Access Compliance Report

Public Rights-of-Way

(Curb Ramps)

Intersection ID: 12928	Main Street: PENMAN_ST	Cross Street: QUINCEY_ST	Location:	N
ADA ID: 28F9639F1CF0	Ramp Type: PerpDiag	Initial Pass/Fail: Fail	Overall Compliance: No	Severity Score: 12.5

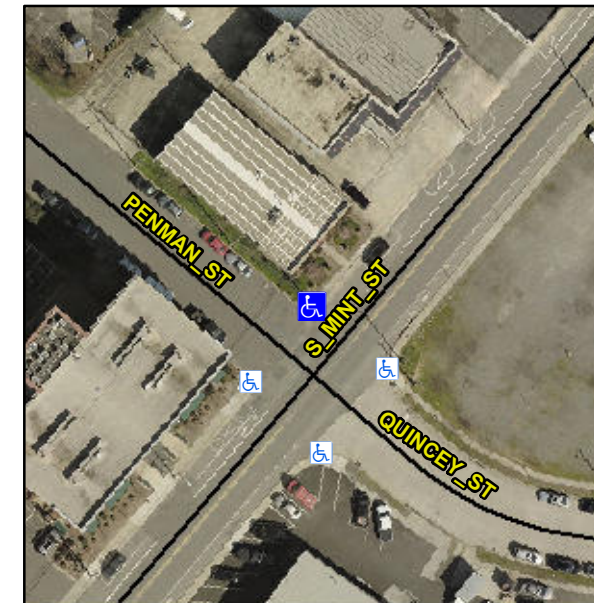
Remove & Replace Curb Ramp With Two New Directional Ramps or Equivalent.

R304.2.2

Compliance	Description	Data	Compliance	Description	Data
N/A	Ramp Length (in)	48.0	No	Ramp Slope (%)	9.6
Yes	Ramp Width (in)	48.0	Yes	Ramp XSlope (%)	1.6
N/A	Flare Type LT	N/A	N/A	Flare Type RT	N/A
N/A	Flare Slope LT (%)	N/A	N/A	Flare Slope RT (%)	N/A
N/A	Flare Traversable LT?	N/A	N/A	Flare Traversable RT?	N/A
N/A	Landing Length (in)	N/A	N/A	DWS Provided?	N/A
N/A	Landing Width (in)	N/A	N/A	DWS Contrast?	N/A
N/A	Landing Slope (%)	N/A	N/A	DWS Length (in)	N/A
N/A	Landing X Slope (%)	N/A	N/A	DWS Full Width?	N/A
N/A	Landing Curb? (Y/N)	N/A	N/A	DWS Offset (in)	N/A
N/A	Shared Landing?	N/A			
N/A	Gutter Ponding?	N/A	N/A	Gutter Slope (%)	N/A
N/A	Gutter Lip Ht (in)	N/A	N/A	Gutter X Slope (%)	N/A
N/A	Painted X Walk1?	No	N/A	Painted X Walk2?	No
	X Walk 1 Direction	To SW		X Walk 2 Direction	To SE
N/A	X Walk 1 Width (in)	N/A	N/A	X Walk 2 Width (in)	N/A
	X Walk 1 Slope (%)	3.6		X Walk 2 Slope (%)	3.2
	X Walk 1 X Slope (%)	0.5		X Walk 2 X Slope (%)	1.6
